SUBJECT: Submits proposed mod to amend requests Revs A & B re overall conversion of current TS to improved TS based upon NUREG-1434, rev 1.

Subject: **WNP-2, OPERATING LICENSE NPF-21
REQUEST FOR AMENDMENT TO TECHNICAL SPECIFICATIONS**

REQUEST FOR AMENDMENT TO THE TECHNICAL SPECIFICATIONS

| Figure 1 | EDG-1 and EDG-2 1995 Test Load Field Current (V Curve) |

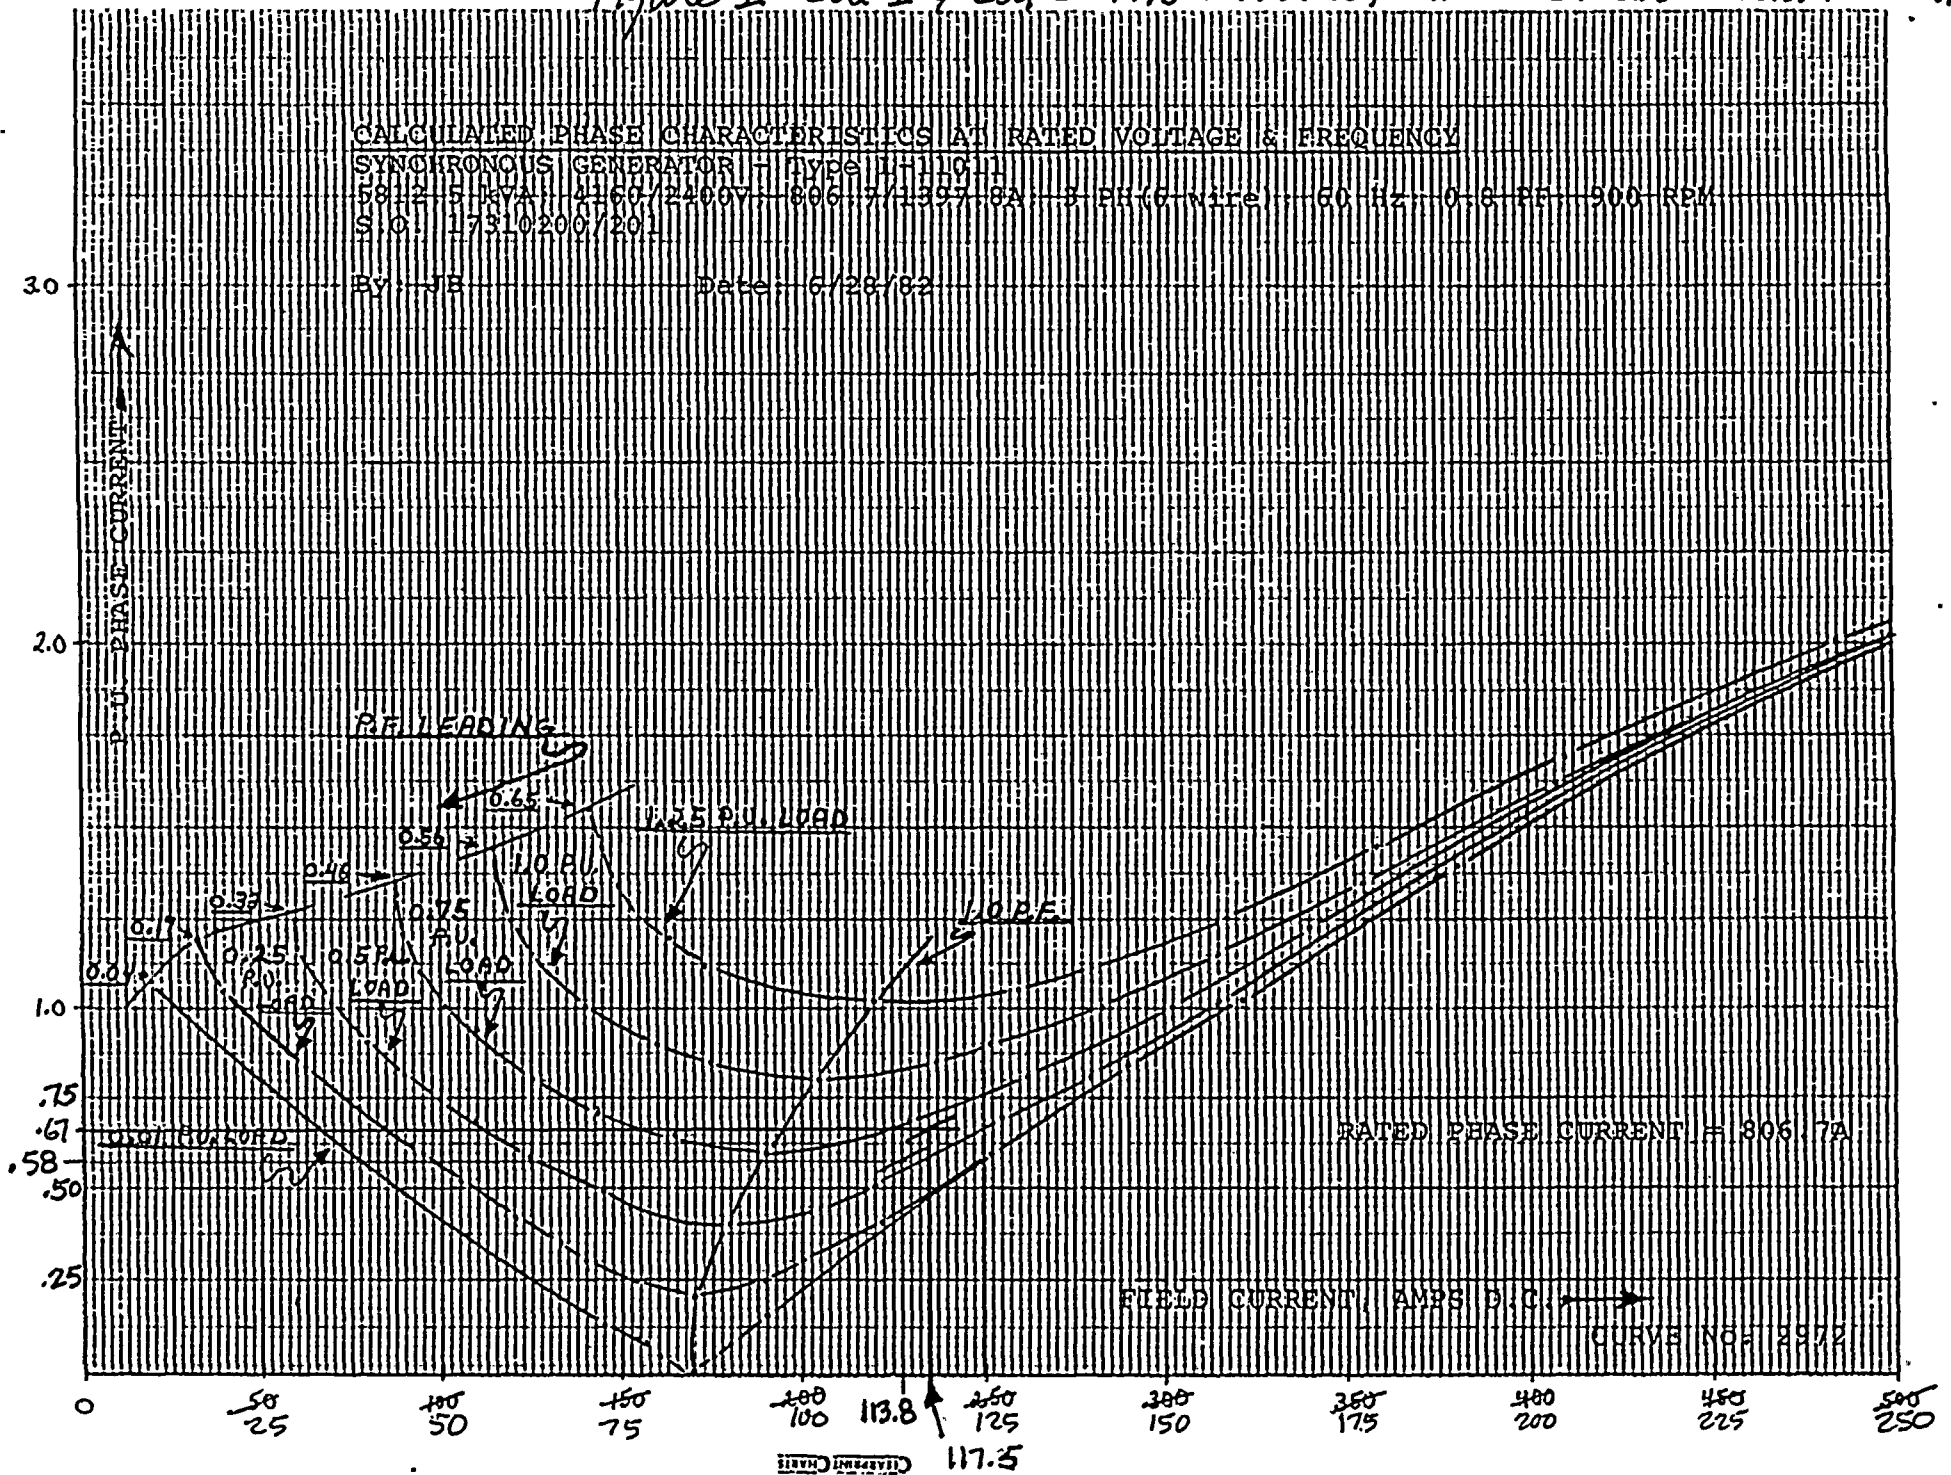
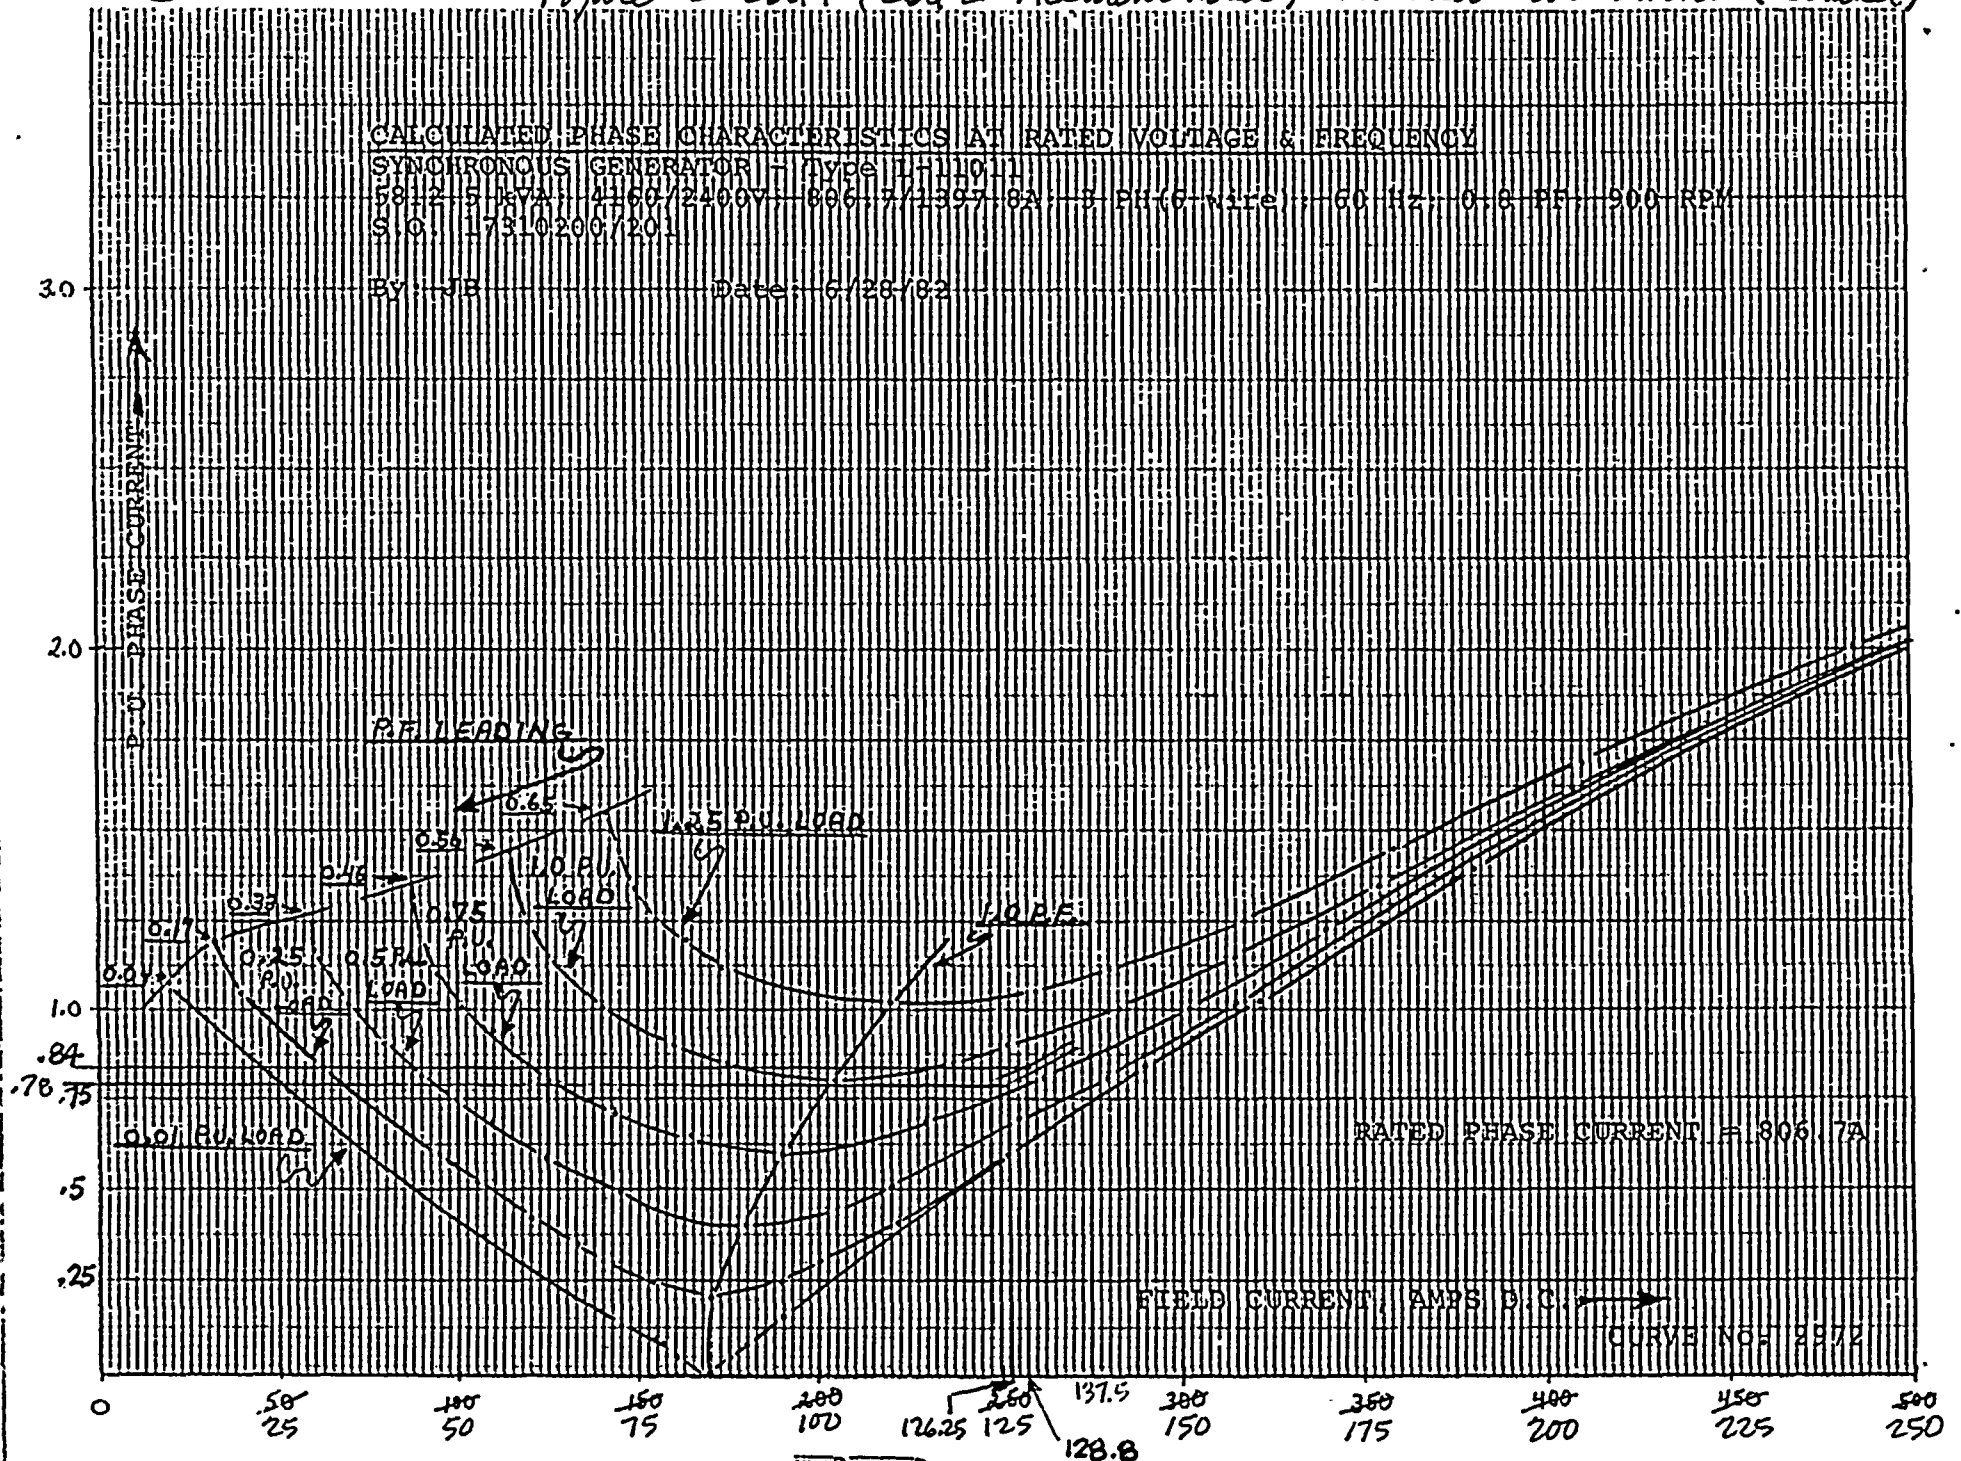
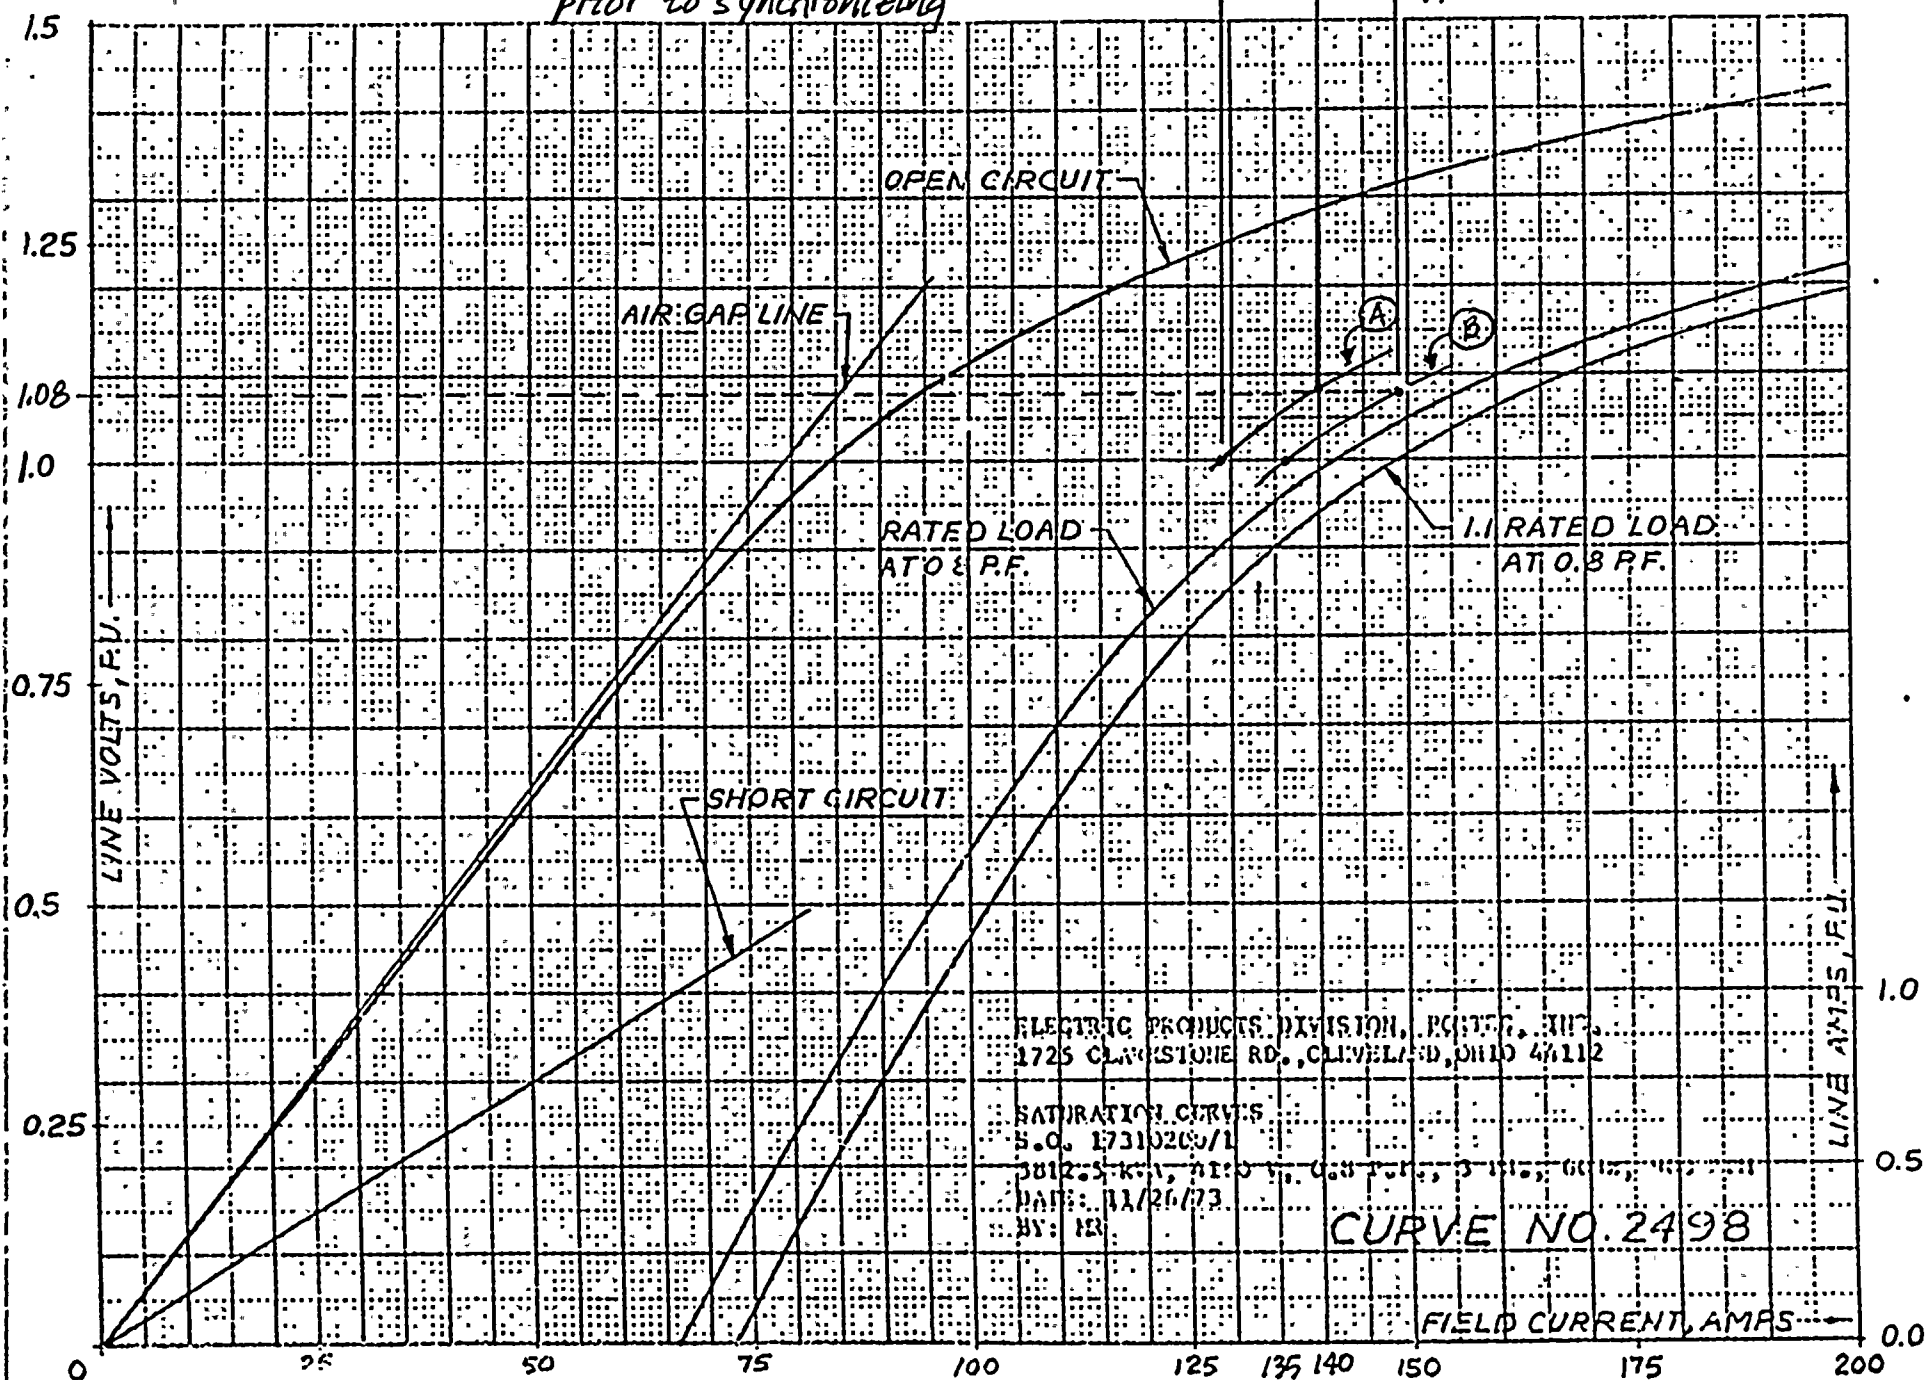
With calculated maximum automatically connected (steady state) accident loads running on the safety bus, EDG-1 may need as much as 140 amps DC field current while DG-2 may need about 136 amps DC field current to restore the offsite power supply, under the highest expected grid conditions (Figure 3). This estimate also shows available margin to allow for meter accuracy and any differences between calculated performance characteristics and equipment ratings. Curve B on Figure 3 shows the estimated margin to the exciter short time rating of 149 amps

Results also indicate that under worst case high voltage grid conditions with the EDG running isolated on the safety bus for test or with postulated maximum automatically connected accident load conditions, the EDG exciters may require field current in excess of full load continuous rating (but within its short time ratings) in order to synchronize to the offsite source. Therefore, appropriate procedures will be revised to include guidance to operators to avoid excessive overloading of the static exciters when synchronizing a loaded safety bus to the offsite source.
